## REMARKS

## **DRAWING AMENDMENTS**

Applicants respectfully request amendment of figures 6B and 8C.

Figure 6B

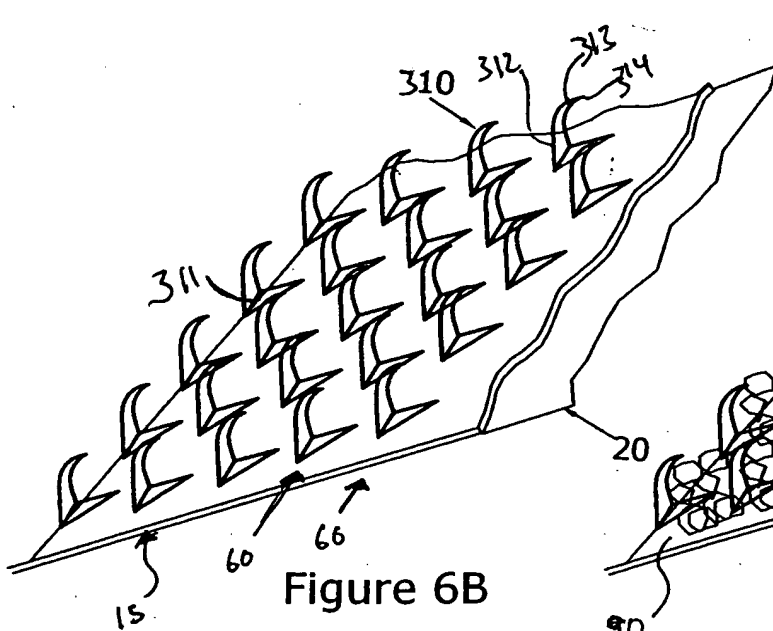
Applicants request amendment of figure 6B to change: reference  
number 11, to reference number 311; reference number 12, to reference  
10 number 312, reference number 13, to reference number 313; reference  
number 14, to reference number 314, as described in the specification at  
paragraph 69.

Figure 8C

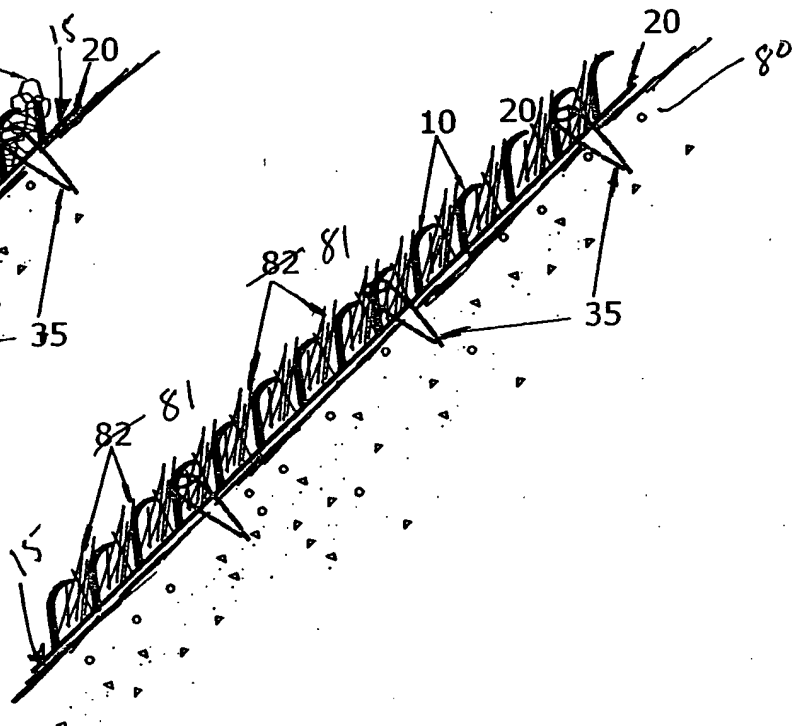
Applicants request amendment of figure 8C to change reference  
number 82 to 81, as described in the specification at paragraph 95.
